Small Scale Stormwater Demonstration Projects (S3DP)

Maintenance Inspection Checklist

Program Site Name: Key Bank	
Address: 15619 Waterloo Rd, 44110	
Inspector's Name: Christopher Hartman, CPESC, CPSWQ, CESSWI	Date and Time: 06/15/2018 2:21 PM
Overall Notes: <ol style="list-style-type: none"> 1. Runoff was observed entering the storm drain inlet nearest the entrance of the property, thereby bypassing the bioretention cell. 2. Minor amount trash debris in practice near the entrance of the location. Applicant needs to remove. 3. Applicant needs to place solid lids on the parking lot inlets, per the original approved plan. 4. Applicant needs to remove the matting that is clogging the practice. 5. At the rear cell, rocks need to be formed in a concave manner to ensure water flow no longer causes soil erosion.

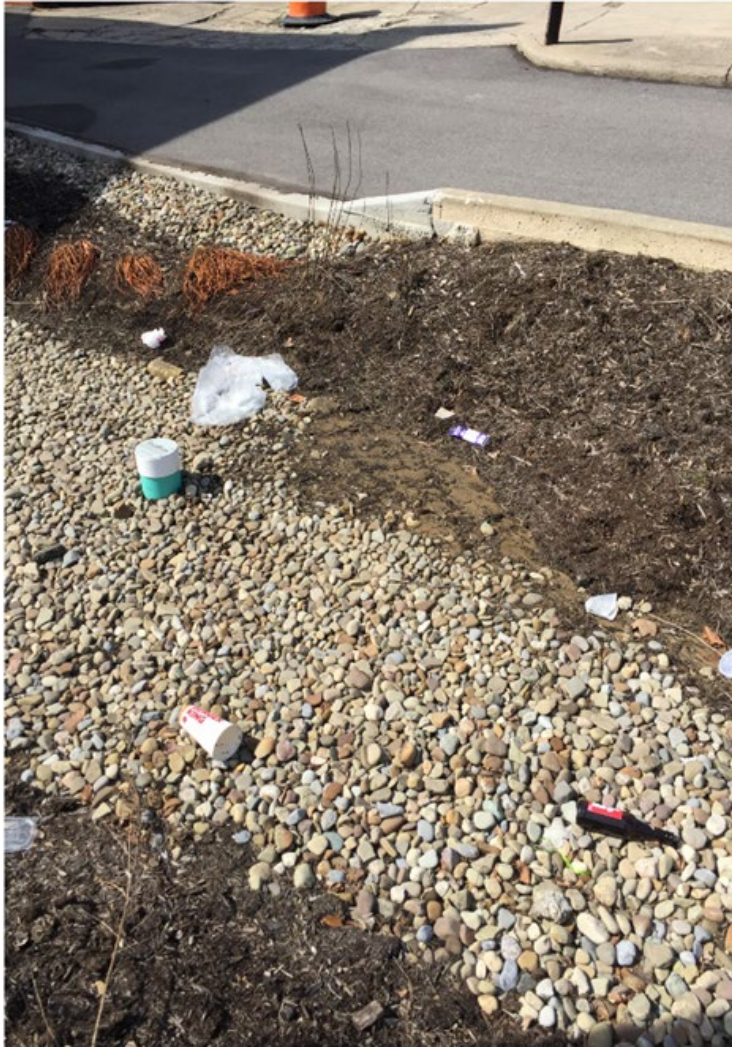
Since last visit the outlet lid had been addressed but flow is still entering the outlet. 4/2/2019

Recommend removing feet from lid and sealing the lid.
